**ENC424J600/624J600 Silicon Errata
and Data Sheet Clarification**

The ENC424J600/624J600 devices that you have received conform functionally to the current Device Data Sheet (DS39935B), except for the anomalies described in this document.

FIGURE 1: 10Base-T MAU EYE DIAGRAM

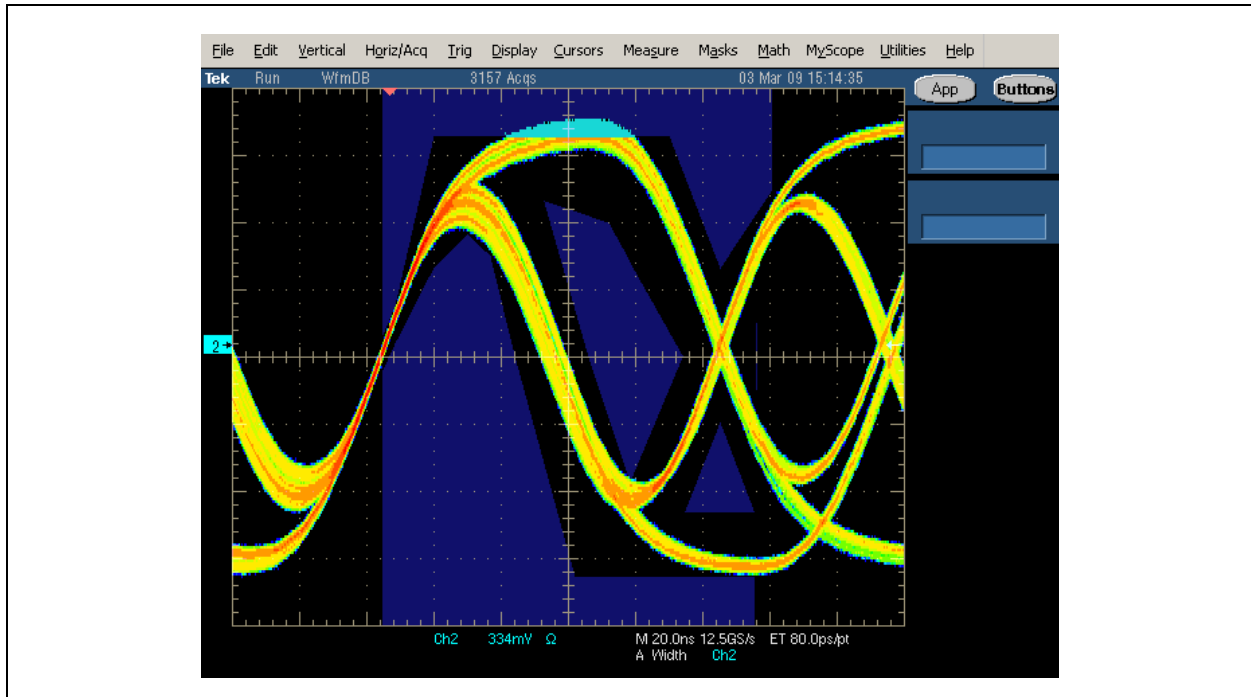
When transmitting random data in 10Base-T mode, the PHY transmit waveform slightly violates the MAU eye diagram keep-out zones specified in the IEEE 802.3™ Std. 2005, Section 14.3.1.2.1. Specifically, the waveform amplitude is slightly too high for '0' to '1' and '1' to '0' bit transitions when tested against the twisted-pair model, as shown in Figure 1.

This issue applies only to 10 Mbps speed and is unlikely to cause compatibility problems in real networks. When terminated with a 100Ω resistor without the twisted-pair model, the transmit waveform stays within the amplitude limits of +2.2V to +2.8V and -2.2V to -2.8V required by the standard.

None.
